WILLIAMSON COUNTY, TEXAS
CHANGE ORDER NUMBER: 2

Project: 1604-075
Roadway: CR 110 South
CSJ Number: _____

**County Road 110 South
Williamson County Project No. 1604-075**

Change Order No. 2

3'-0" x 4'-6" x 4'-6" I.D.

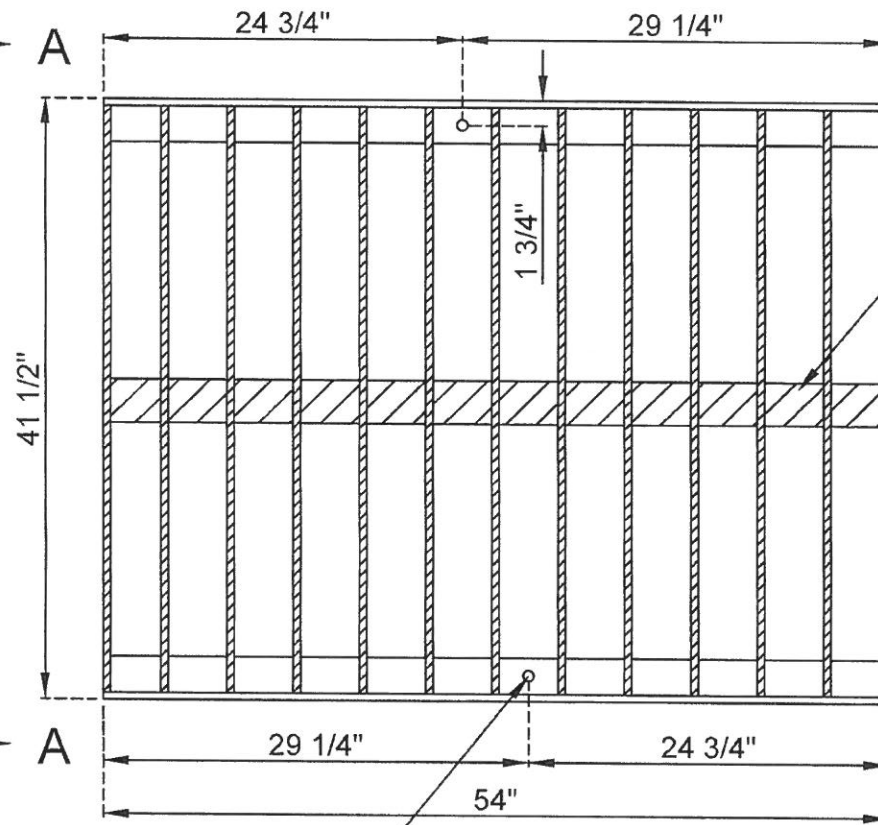
PROBLEM: Culvert Flow lines are 2 to 3' lower than ditch lines shown in the cross sections, creating much deeper back slopes. ROW location on sheet 154 for culvert 5 does not match cross sections.

Delete parallel wingwalls for Culverts 4 & 5, replace with drop inlets. Reconfigure ditch grades to accommodate drainage upstream and downstream in east ditch line.

Please refer to culvert grading shown on sheet 156 for structure 5. Sheet 154 has been revised to show a grate inlet on upstream side of structure 4.

Galvanized Steel Grate
Type I Grate Modified (41 1/2" x 54" O.D.)

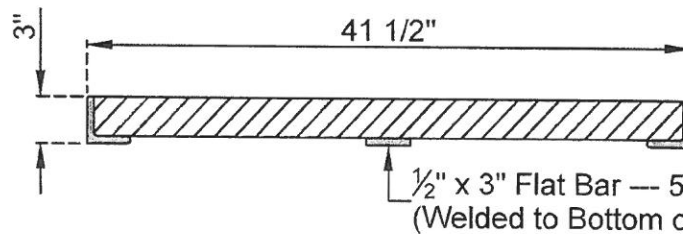
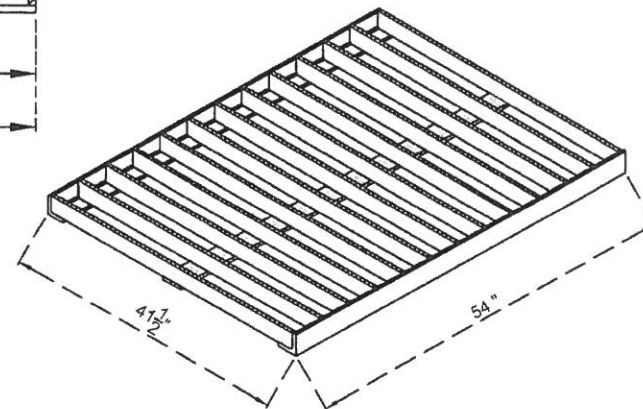
TYPE I Grate
MODIFIED
41 1/2" x 54" O.D.
Tx. D.O.T.
